Form No.: 160.00-M1 (LS01)	801
	Supersedes: None	
<b>LITERATURE SUPPLEMENT</b>	File with: 160.00-M1	
Subject: IEEE 519 Logic Board Software Upgrade

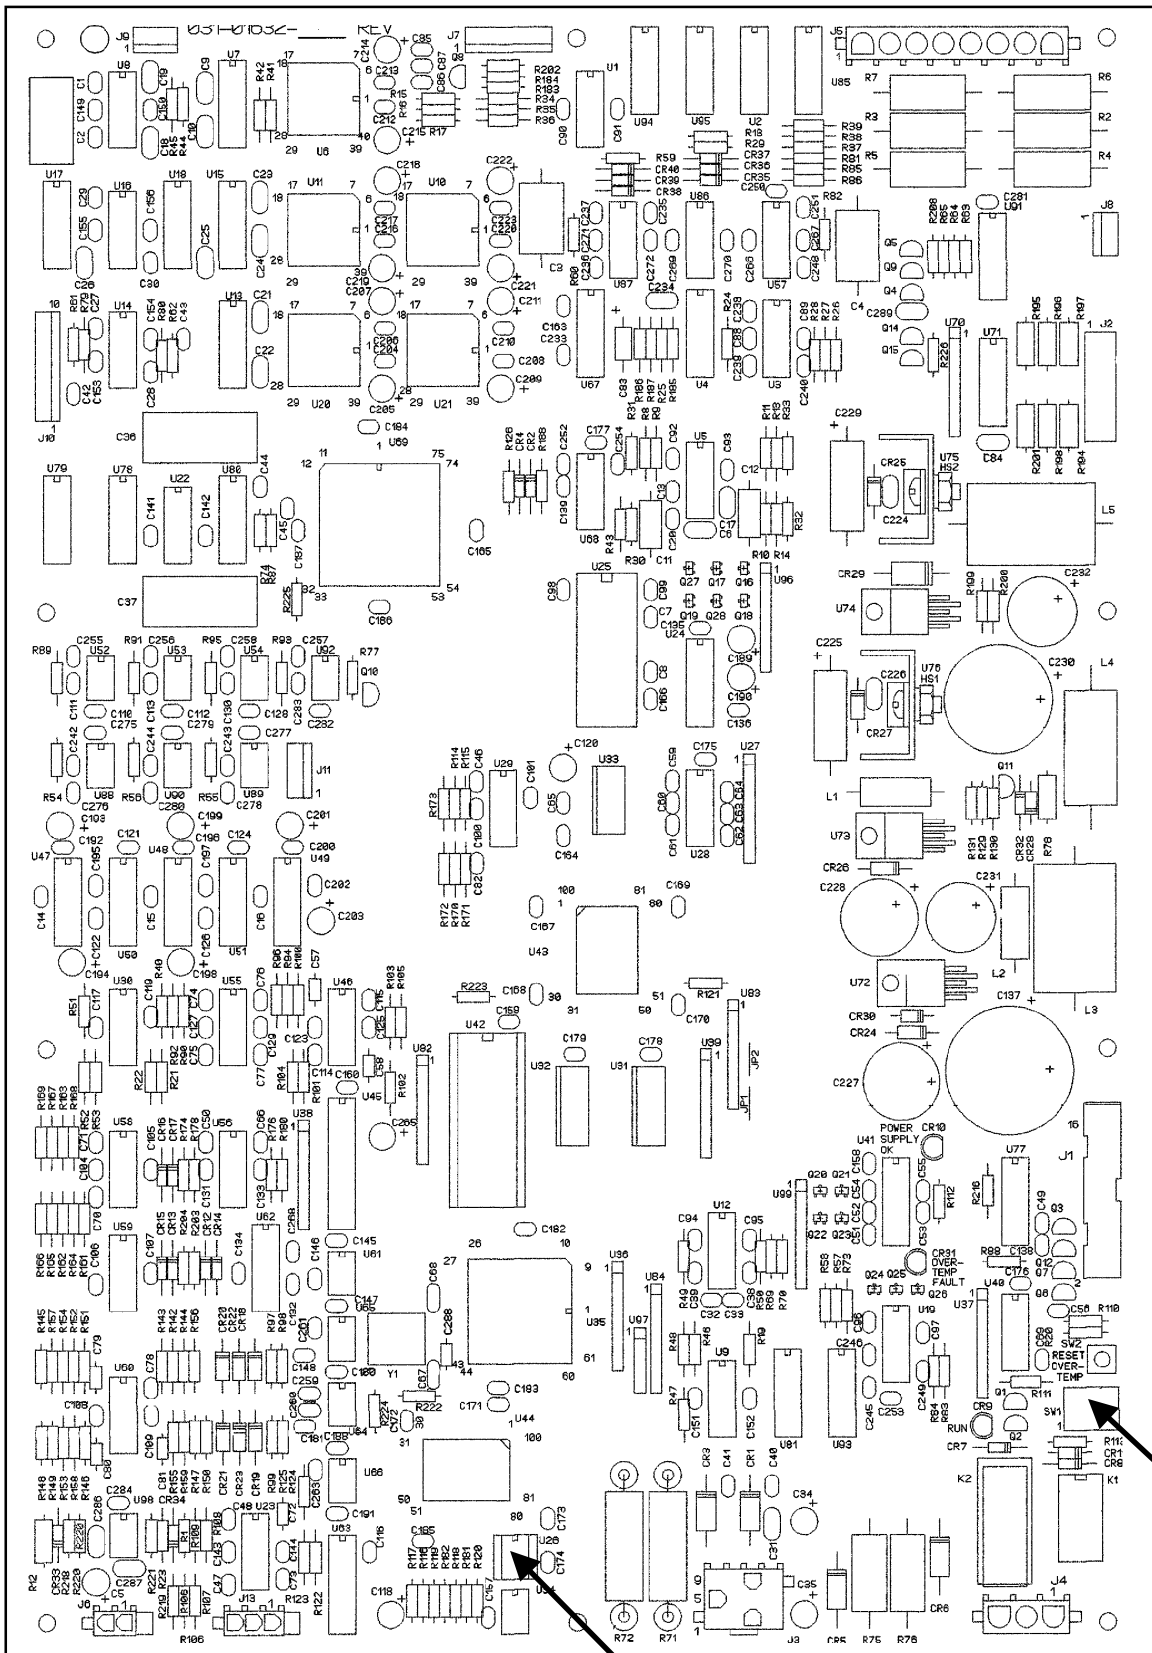
Recent field reports have indicated that chiller shutdowns are sometimes occurring due to the 519 filter having filter phase over current faults. Most of these faults have been caused by the switching of power factor capacitors by the utility, or locally by the customer. These same faults can occur when the customer has a heavily loaded transformer. This software upgrade will eliminate most of the nuisance filter phase over current faults.

If you are experiencing this type of problem with a 519 filter, then order the upgraded U26 chip from the Baltimore Parts Center. The part number for the chip is 031-01680-002 and the check sum is EA3B.

When you receive your part you will find an 8-pin chip to be installed in U26 on the 519 Logic Board. Verify the check sum to be EA3B.

Refer to the back of this sheet for the location of U26 on the logic board. Remove the existing chip in the U26 slot from the 519 filter logic board (031-01632-0XX) and replace it with the new chip from the Baltimore Parts Center check sum EA3B. When installing the new chip ensure that the notch on the chip is pointed toward the top of the board.

If the filter has been disabled, then reconnect the 16 pin ribbon cable between the VSD logic board and the 519 filter logic board. Place SW1 in the up position. Refer to the back of this sheet for the location of SW1.
